RAI Volume 3, Chapter 2.2.1.2.2, Second Set, Number 1

Justify the use of Total System Performance Assessment (TSPA) v5.000 in the igneous event sensitivity analyses (SNL, 2008, Appendix P), when TSPA v5.005 was used to evaluate the igneous event scenario in the license application.

Figure 1 Comparison of Mean Annual Dose for the Igneous Intrusion Modeling Case: Base Case and Probability of the Igneous Event Set to 10^{-7} per Year for (a) 10,000 Years and (b) 1,000,000 Years, for TSPA-LA Model v5.000 and v5.005

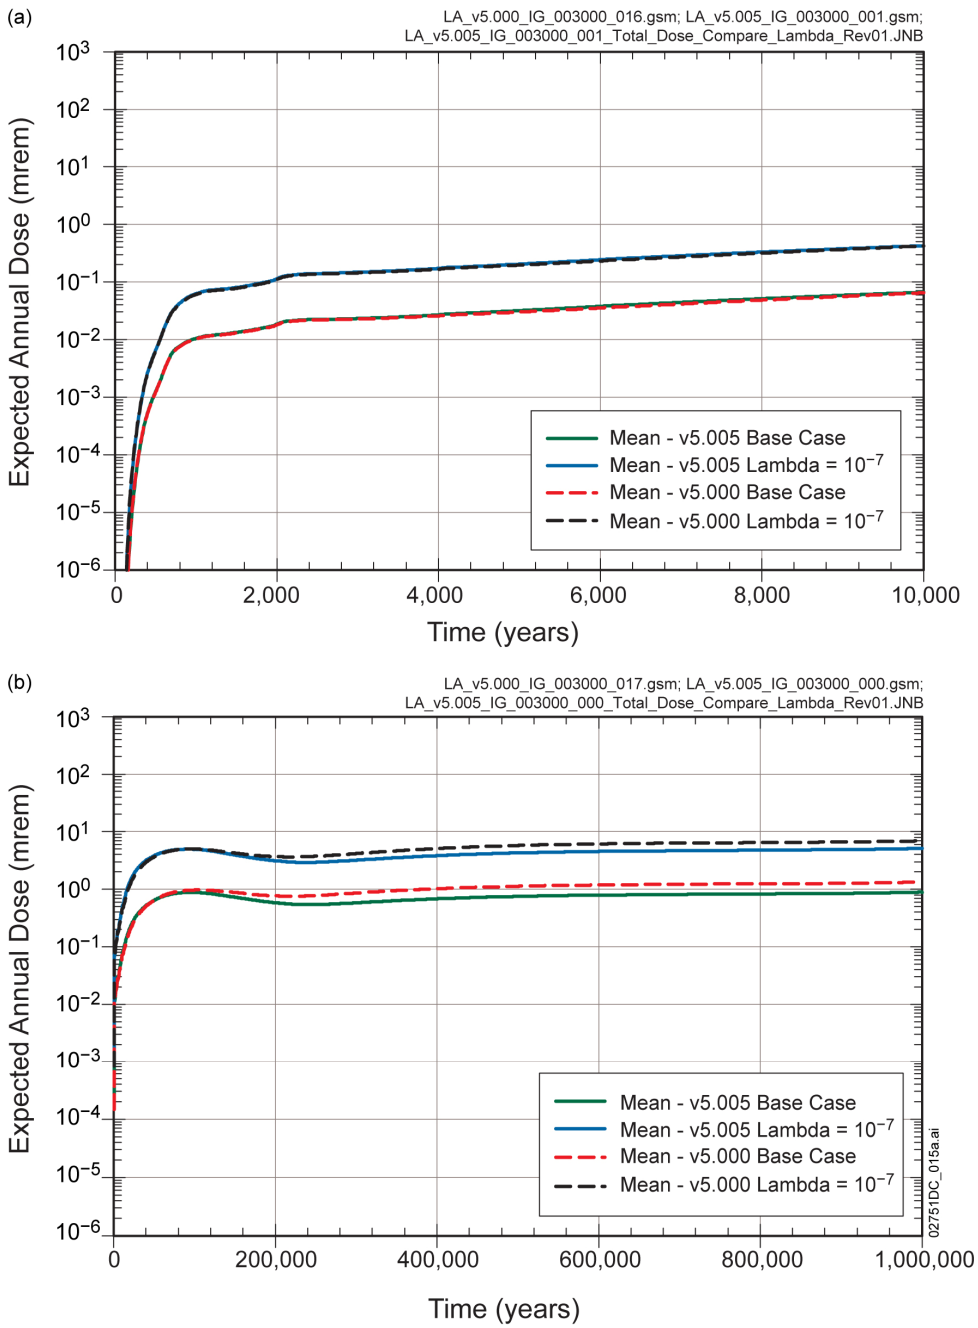
Basis: As part of igneous scenario analysis, the DOE provided sensitivity analyses using a single-value probability of intrusive and extrusive igneous events at 1 x 10^{-7} per year (SNL, 2008, appendix P). The igneous intrusive sensitivity analyses were identified as LA_v5.000_IG_003000_16.gsm and LA v5.000_IG_003000_17.gsm (SNL, 2008, Appendix P, pg P-44). However, these analyses were performed using a version of the TSPA identified as v5.000, which is not the version used for license application dose calculations. Instead the license application relies on a TSPA version v5.005. This information is needed to verify compliance with 10 CFR 63.114.

Figure 1 shows the results of the updated sensitivity analysis for the Igneous Intrusion Modeling Case using TSPA-LA Model v5.005. With an event frequency of 10^{-7} per year, the mean annual dose from igneous intrusion increases by a factor of five to seven. This increase is similar to that observed for TSPA-LA Model v5.000 (SNL 2008, Appendix P, Section P14.3, Figures P-6 and P-7). Thus the effect on the mean annual dose of fixing the igneous frequency at a constant

value is the same for either TSPA-LA Model v5.000 or TSPA-LA Model v5.005. The differences between the results in Figure 1 for TSPA-LA Model v5.005 and TSPA-LA Model v5.000 are due to the changes to the TSPA-LA Model between these versions, as described in *Total System Performance Assessment Model / Analysis for the License Application* (SNL 2008, Appendix P[a]).
